Item Number: 25B-RR-01

NCUTCD PROPOSAL FOR CHANGES TO THE MANUAL ON UNIFORM TRAFFIC CONTROL DEVICES

COMMITTEE / TASK FORCE: Railroad and Light Rail Transit Technical Committee
ITEM NUMBER: 25B-RR-01
TOPIC: Removal of Defined Length and Width of Retroreflective Strip
ORIGIN OF REQUEST: Railroad and Light Rail TC
**AFFECTED SECTIONS
OF MUTCD:** 8D.03, Figure 8D-1

Figure 8D-1. Composite Drawing of Active Traffic Control Devices for Grade Crossings Showing Clearances

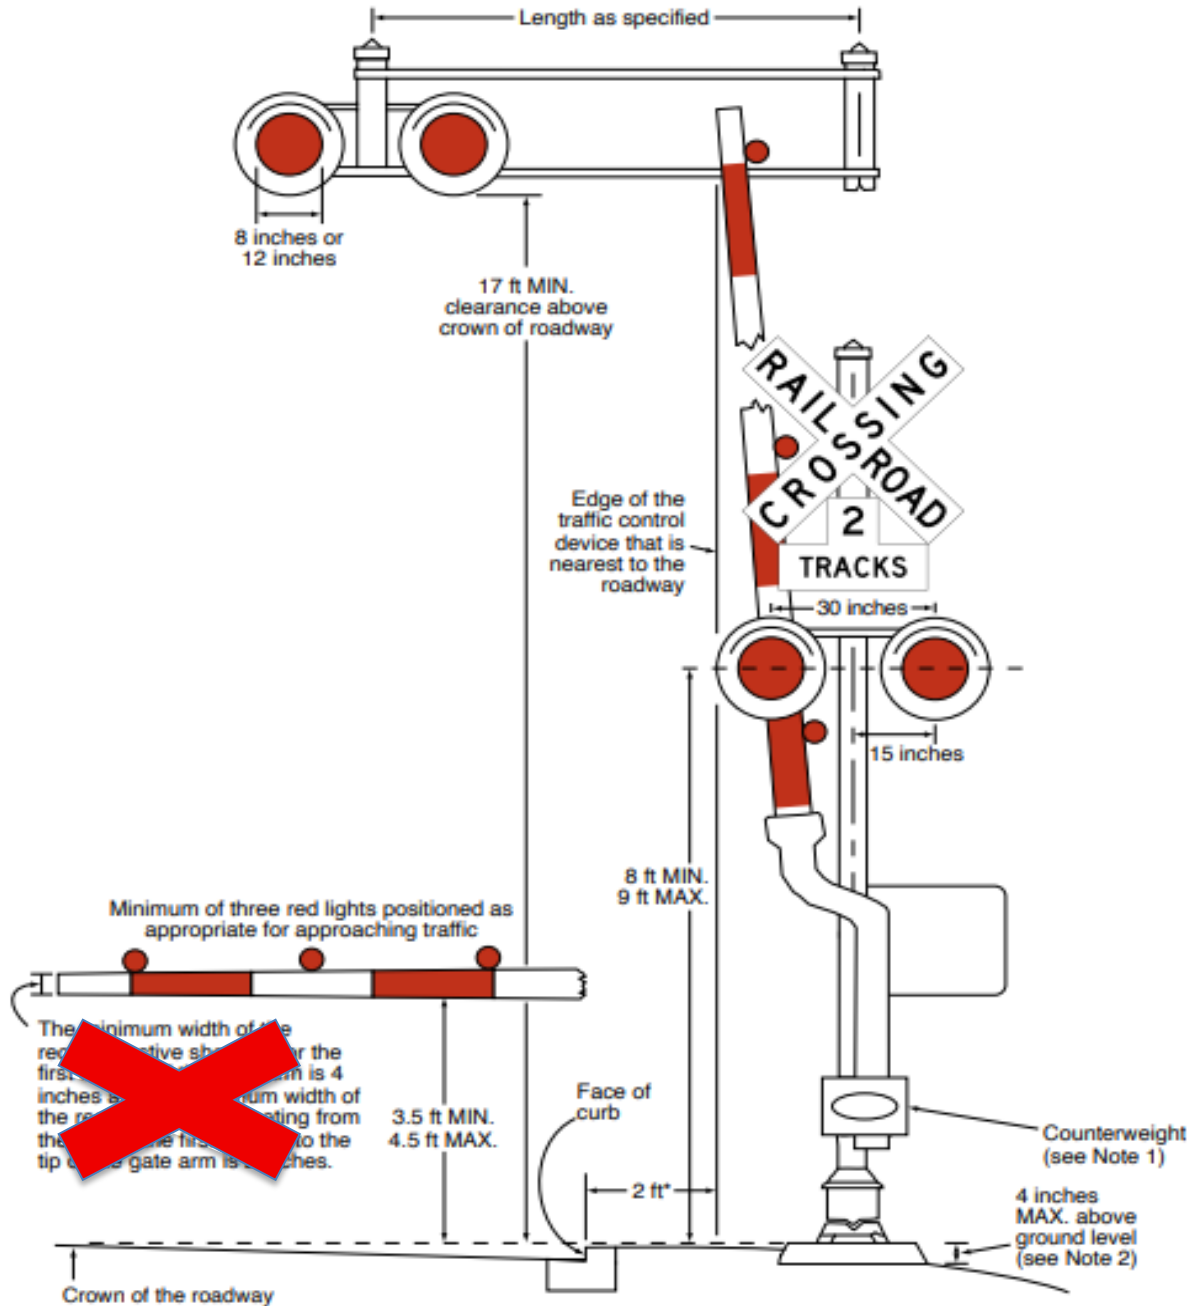
This proposal is for the change in section 8D.03 to provide for the requirement of the width of reflective material to include the entire gate and be determined by the width of the gate section and not an arbitrary length.

The 2009 edition required that the gate arm be fully reflectorized. The 11th edition added a minimum length 32 feet and width 4 inches for the reflective material, which in most cases exceeded the actual width of part of the gate arm itself. A significant number of gates being less than 32 feet in overall length have a reduced section at the tip which the requirement of 4-inch retroreflective tape material is not practical.

The common configuration of railroad gates includes a first section and a gate tip section which is less than 4 inches. Longer gates generally consist of three sections. The first section can accommodate the 4-inch reflective tape. The second section can accommodate 3-inch reflective tape. The gate tip section can accommodate 2-inch reflective tape.

05 Gate arms shall be fully retroreflective on both sides and shall have vertical stripes alternately red and white at 16-inch intervals measured horizontally. ~~The width (which becomes the height of the retroreflective sheeting when the automatic gate is in the down position) of the retroreflective sheeting on the front of the gate arm shall be at least 4 inches for the first 32 feet of gate arm length measured from the center of the gate mast. The front of the gate arm beyond 32 feet to the tip of the gate shall have retroreflective sheeting at least 2 inches in width.~~
